22-COA-0112
141 Pope St.

Clifton Architectural Review Committee
Public Hearing

Bradley Fister, Historic Preservation Specialist
June 3, 2022

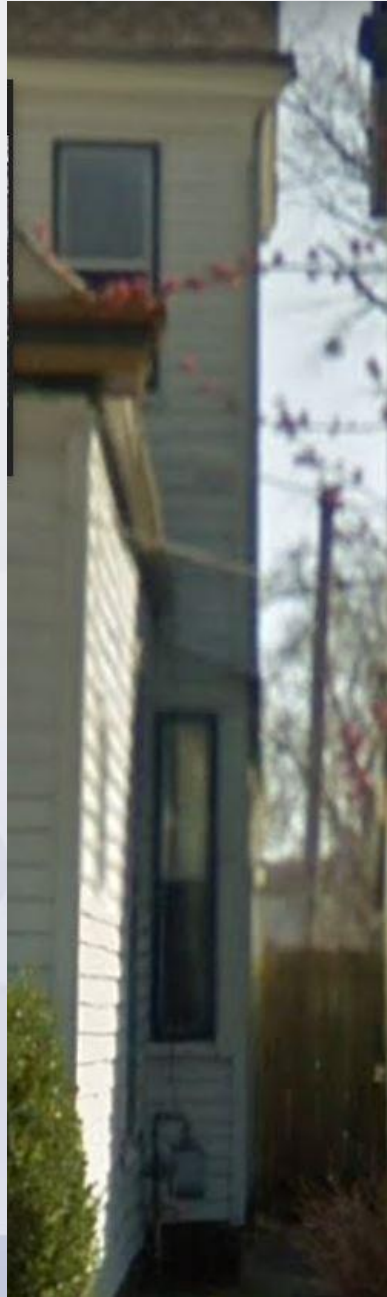
1. The applicant seeks after-the-fact approval for replacement of 3 front facing windows.
2. The applicant seeks approval for the replacement of 2 front facing windows on the second level.

1. The three after-the-fact replacement windows shall be replaced with one-over-one replacement windows that closely match the dimensions of the historic wood windows.
2. The replacement windows for the two front facing second-story windows shall be one-over-one and shall closely match the dimensions of the historic wood windows..
3. All glass shall be clear and non-reflective.
4. The applicant shall not wrap the window trim or sills with vinyl or aluminum.
5. The applicant shall take precautions to preserve any existing wood elements to be reapplied to the building and shall submit photographs of all elements proposed to be reconstructed.
6. The applicant shall take appropriate precautions with the handling of potential lead paint.

9600 Series

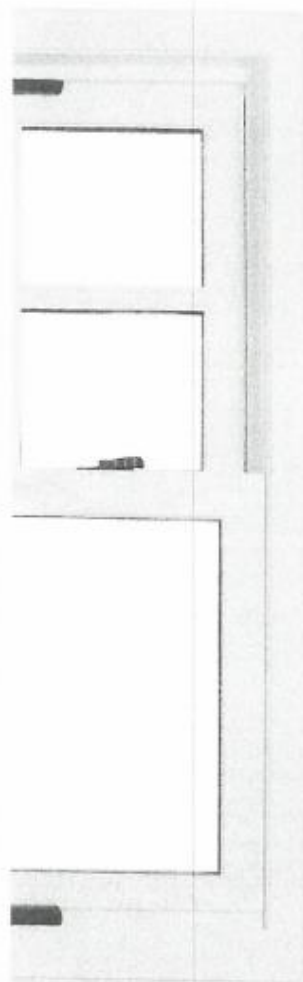
On the basis of the information furnished by the applicant, staff recommends a Certificate of Appropriateness be **denied** as the proposed vinyl replacement windows do not meet the design guidelines.

However, if the ARC determines that the proposed vinyl is an appropriate material, or if the applicant is willing to change replacement window material, then staff recommends a Certificate of Appropriateness be **approved with the following conditions**:
